**ADDENDUM 1**

Marathon County Public Library  
Restroom Renovation  
300 North 1<sup>st</sup> Street  
Wausau WI 54403

Commission No.: O25037  
Addendum Date: August 7, 2025

**BASEMENT RESTROOM PLANS**

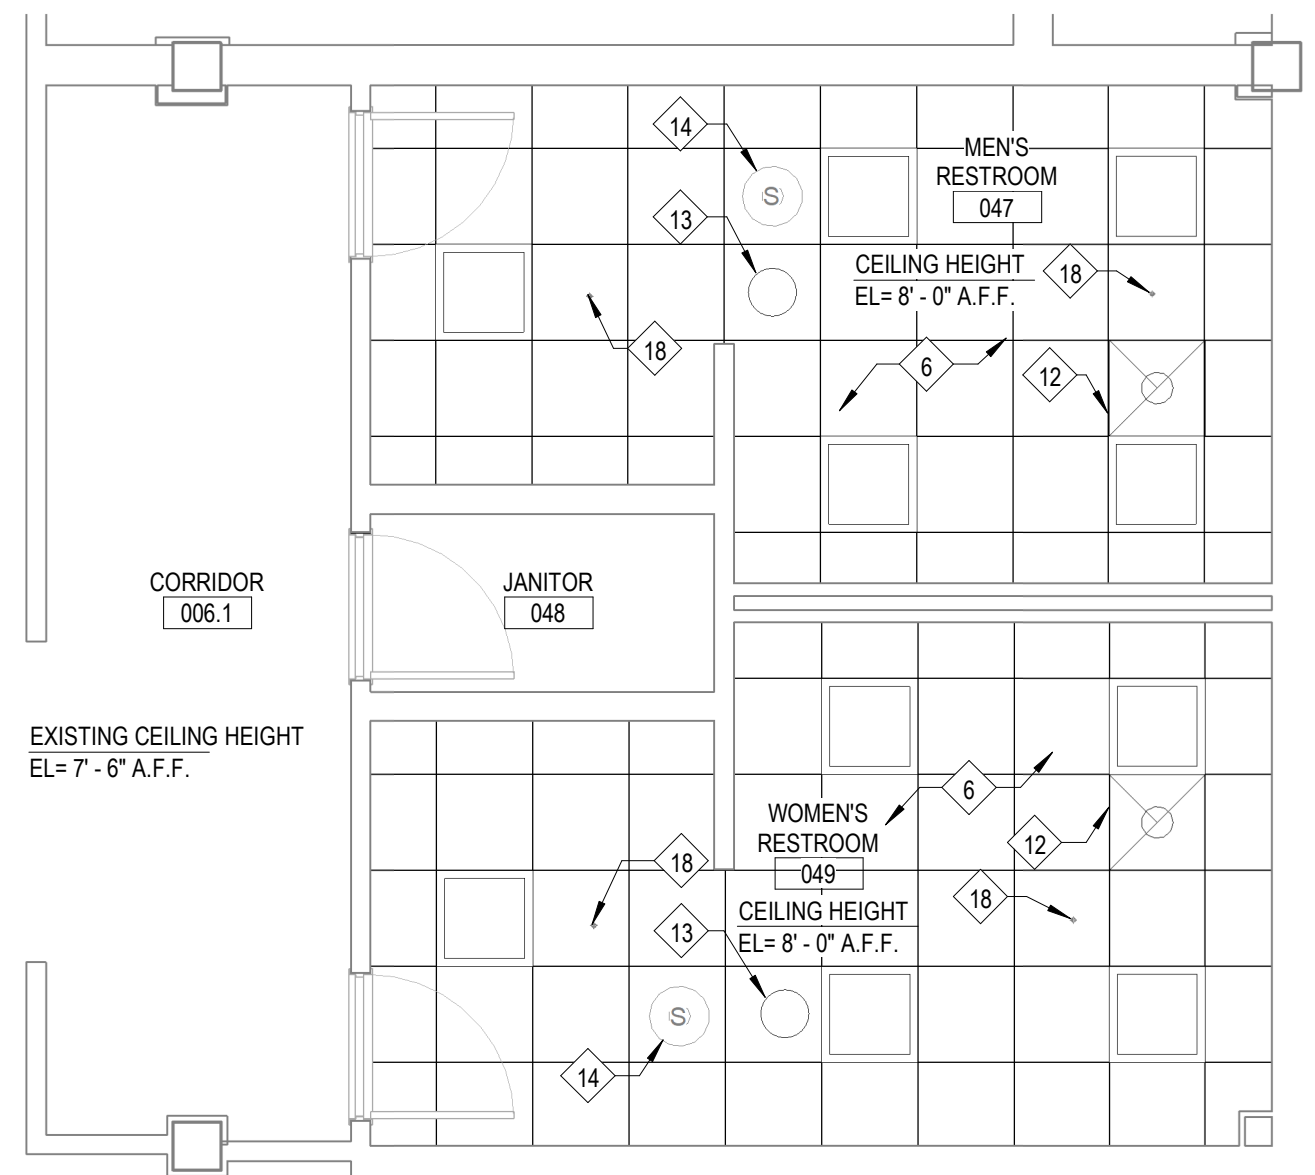
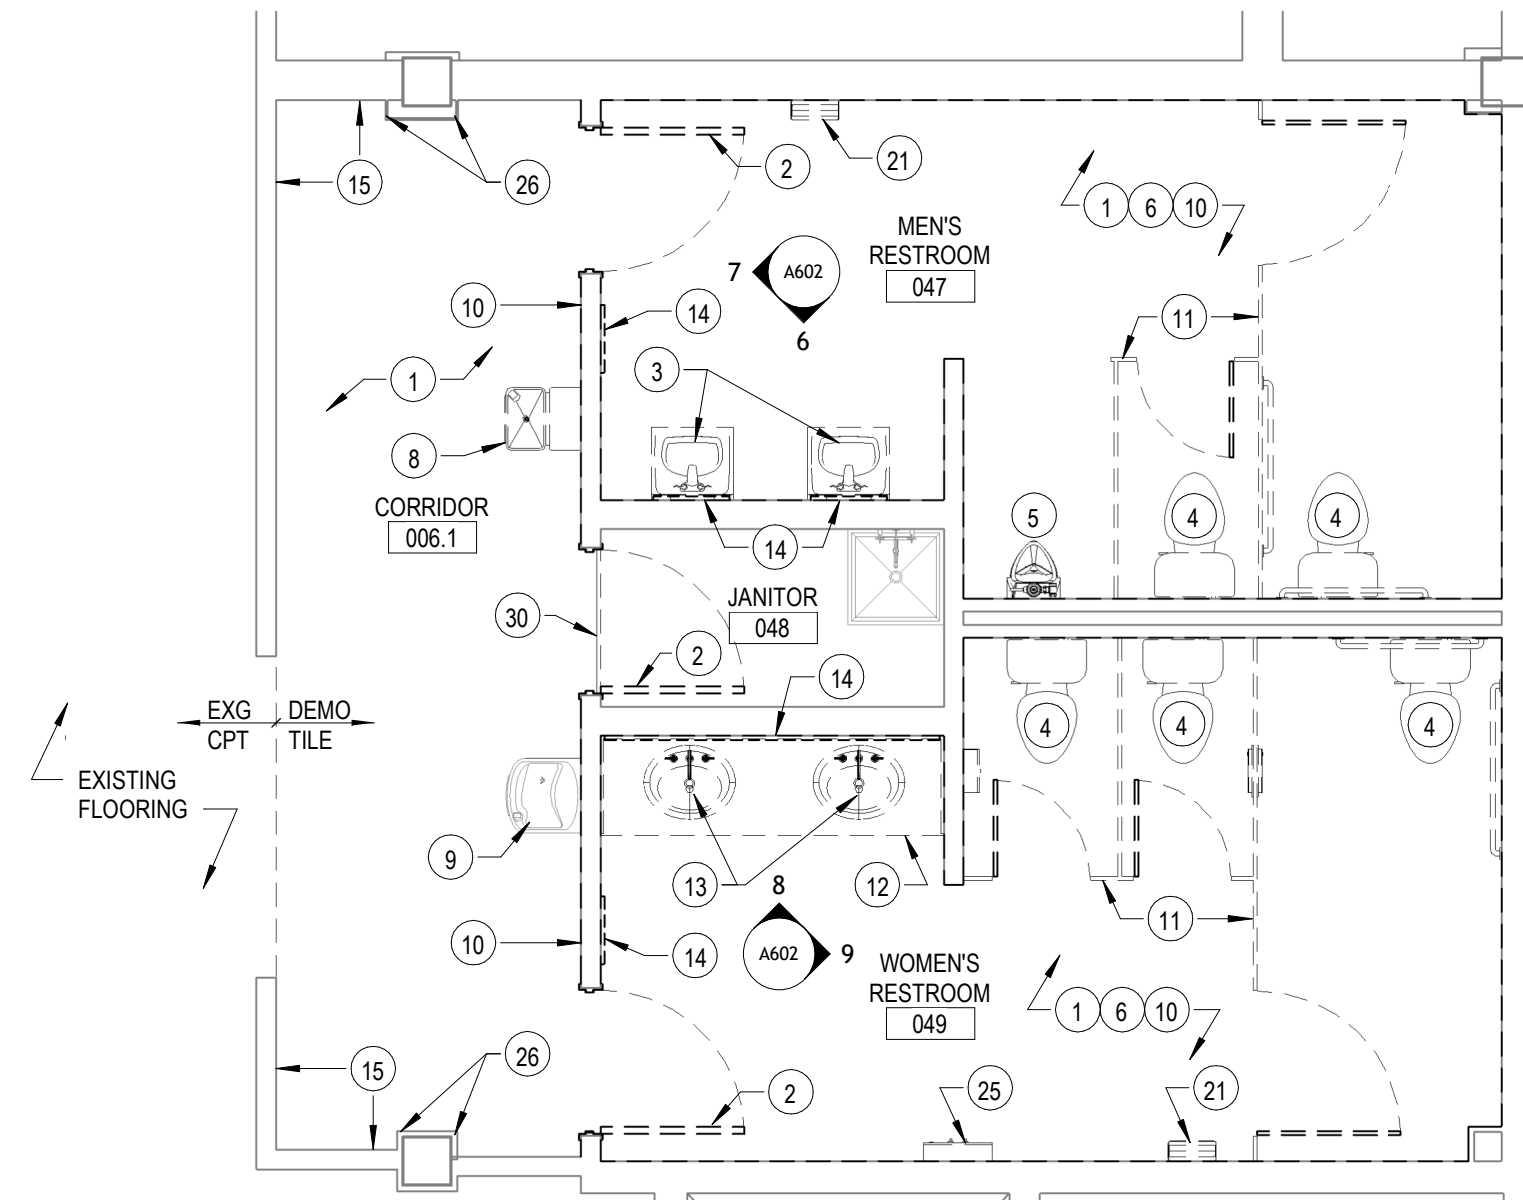
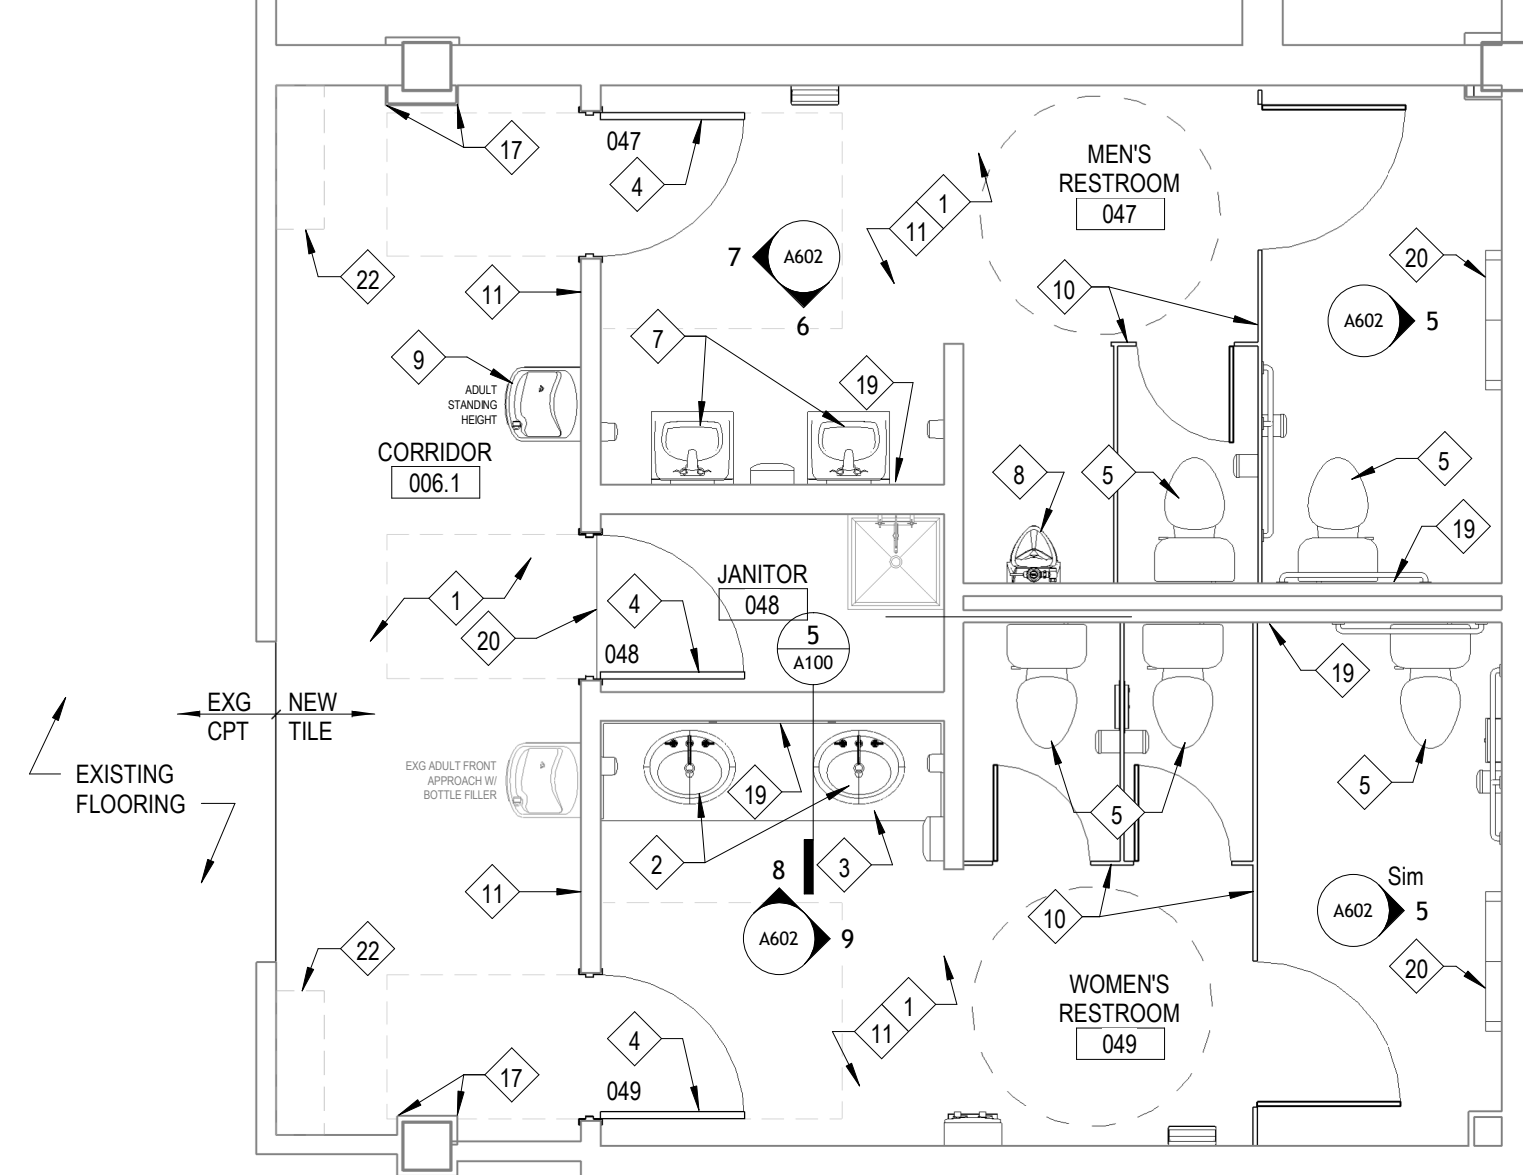
- 1) A100 Basement Restroom Plans
  - a) Demolition Note 3: REVISE to state the following: “Remove existing lavatories and faucets; prepare existing HW, CW, and SAN pipes to accommodate installation of new. Provide temporary seal for sanitary pipes for duration of construction.”

- b) Demolition Note 13: REVISE to state the following: “Remove existing drop-in sinks and faucets; prepare existing HW, CW, and SAN pipes to accommodate installation of new. Provide temporary seal for sanitary pipes for duration of construction.”

- c) Work Description Note 2: REVISE to state the following: “Provide new American Standard ‘Aqualyn’ model 0475.047 drop-in sink with new Sloan ‘Optima’ model EAF-350-BAT-ISM-CP-0.5GPM-AER-IQ-FCT faucet. Provide new grid strainer drain, P-trap, and trap arm. Extend/rework existing CW, HW, and SAN pipes as required for connection.”

- d) Work Description Note 7: REVISE to state the following: “Provide new American Standard ‘Lucerne’ model 0356.421 wall-hung lavatory with new Sloan ‘Optima’ model EAF-350-BAT-ISM-CP-0.5GPM-AER-IQ-FCT faucet. Provide new grid strainer drain, P-trap, and trap arm. Extend/rework existing CW, HW, and SAN pipes as required for connection. If existing fixture carrier or wall hanger is not suitable for re-use, notify the Architect.”
